Improved Technical Specifications

Quad Cities Station

Volume 2:
Sections 3.1 and 3.2

FIGURE 3.4.A-1

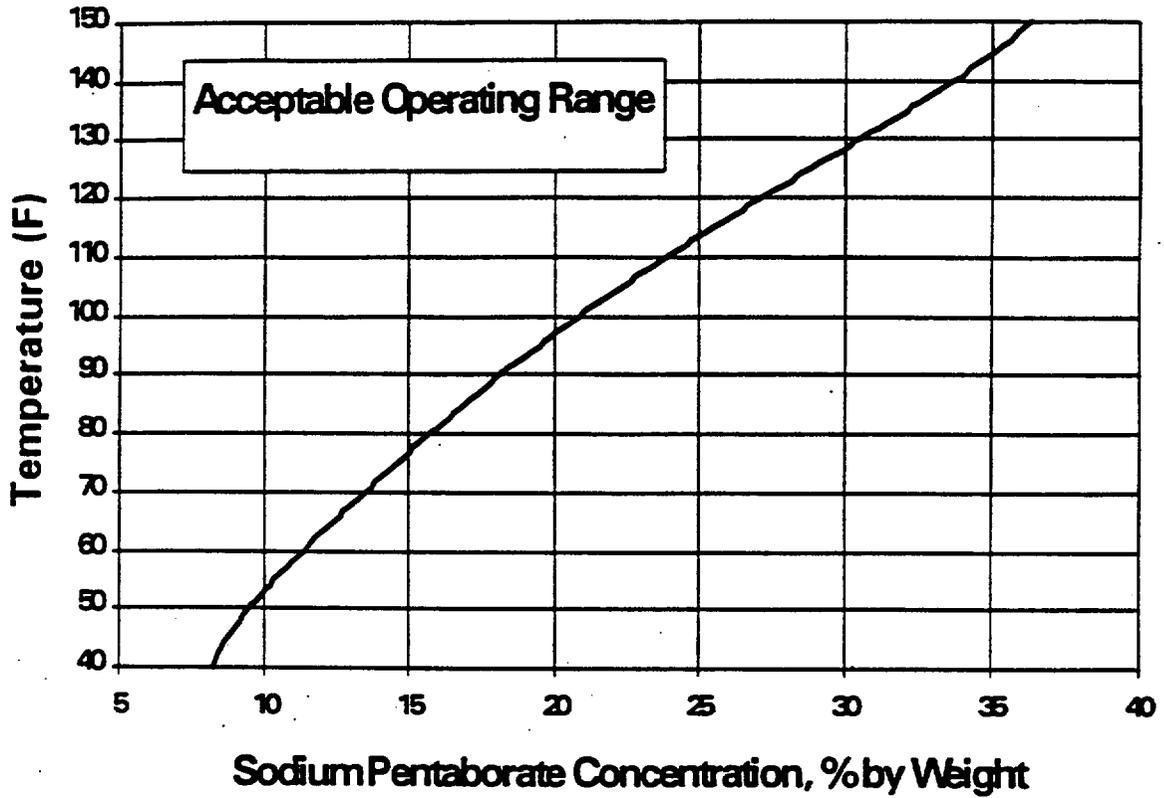
Figure 3.1.7-2

- M.2 (cont'd) Figure 3.1.7-2 (CTS Figure 3.4.A-1). This change is considered more restrictive since an explicit Surveillance will be required whenever the limits of Figure 3.1.7-2 are not met. However, this change is necessary since precipitation of the boron from solution may occur when the temperature requirements are not met.

Figure 3.1.7-1
FIGURE 3.4.A-2

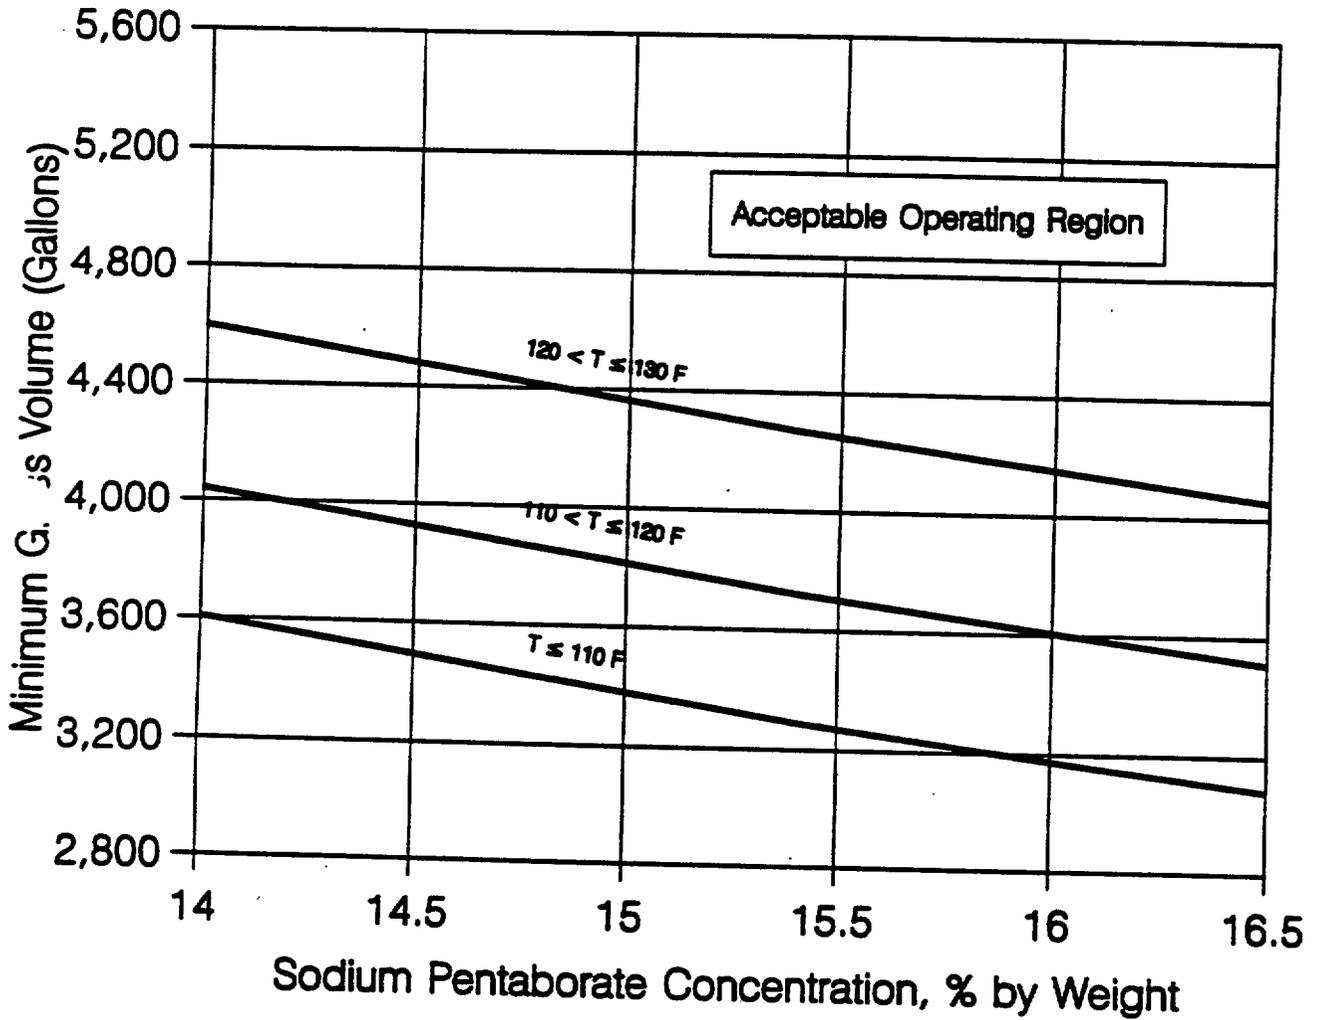
- A.3 The details of CTS 4.4.A.2.b, which identify the available boron concentration to be determined to be 14% to 16.5% by weight, are revised in proposed SR 3.1.7.5 to be within the limits of Figure 3.1.7-1. Since the limits identified in the Figure correspond to the same 14% to 16.5% by weight related to the volume requirement, this change is considered a presentation preference consistent with the BWR ISTS, NUREG-1433, Rev. 1. Therefore, this change is administrative.

Figure 3.1.7-1 (page 1 of 1)
Sodium Pentaborate Solution Volume
Versus Concentration Requirements

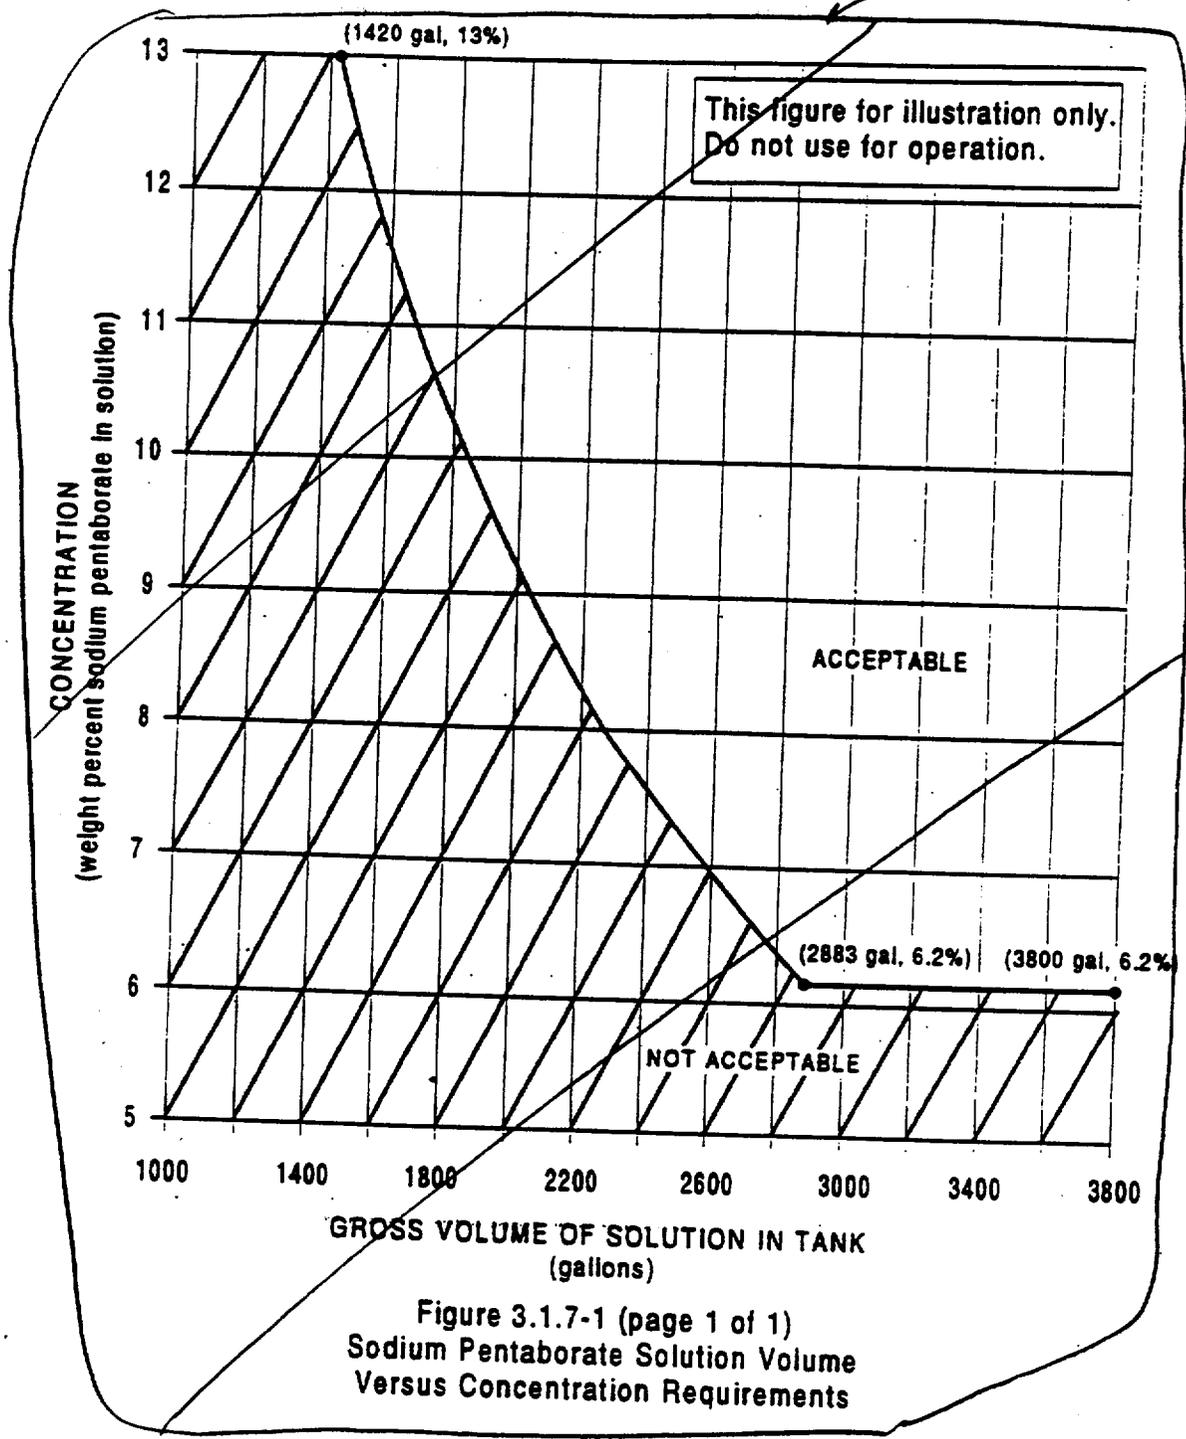
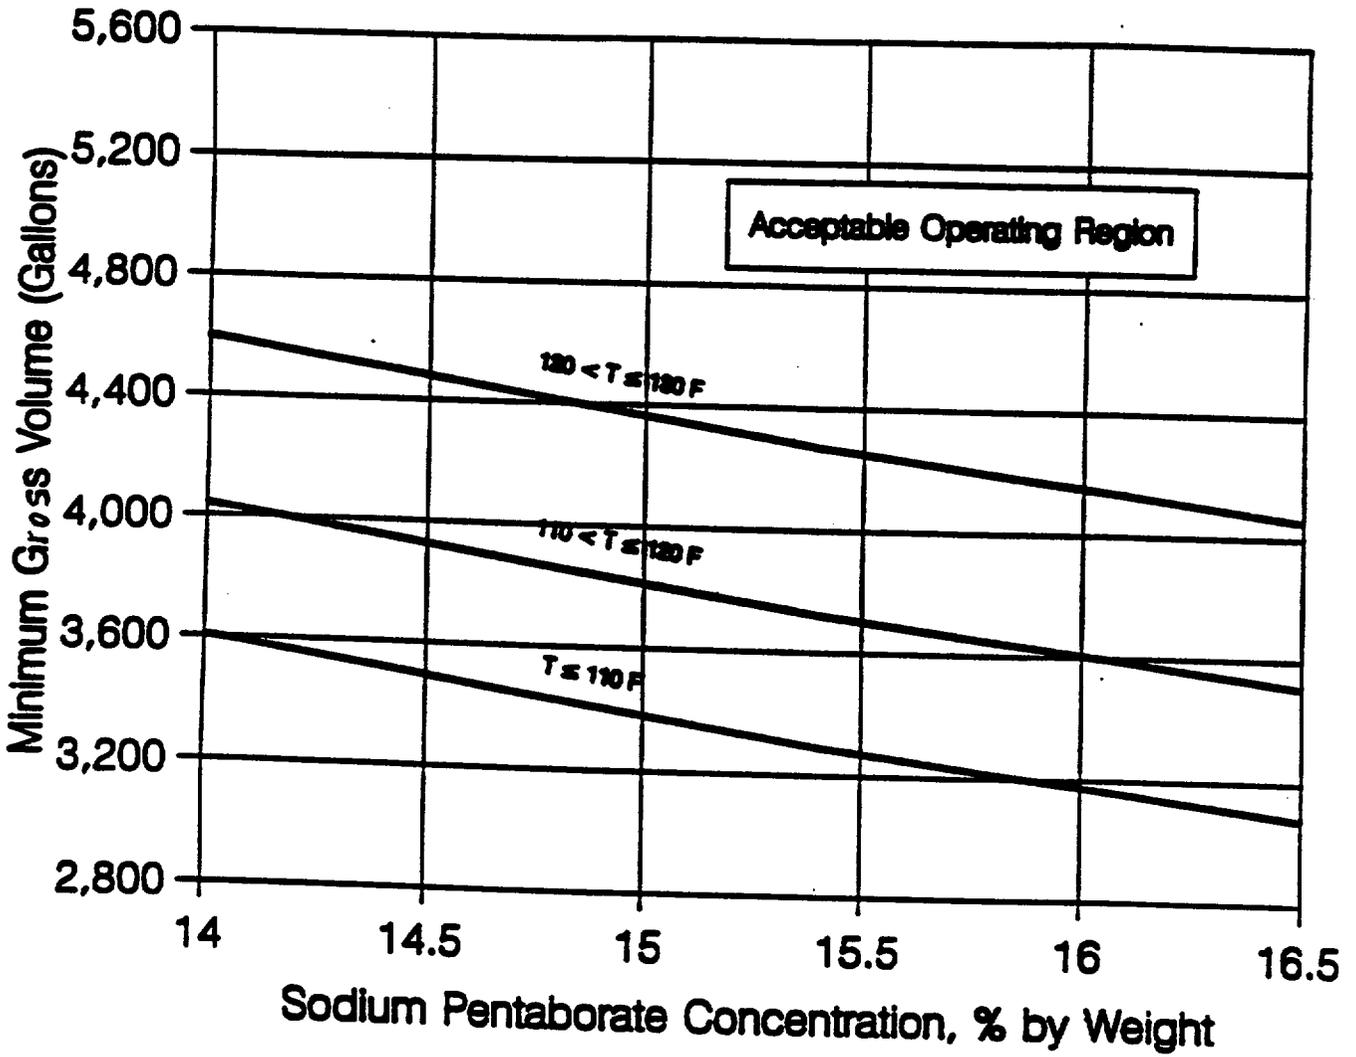
Insert Figure 3.1.7-1

Insert Figure 3.1.7-1

2. The brackets have been removed and the proper plant specific information/value has been provided.
3. The proper Quad Cities 1 and 2 nomenclature has been used (CTS Figures 3.4.A-1 and 3.4.A-2). This is also consistent with the nomenclature used in SR 3.1.7.1 and SR 3.1.7.2.
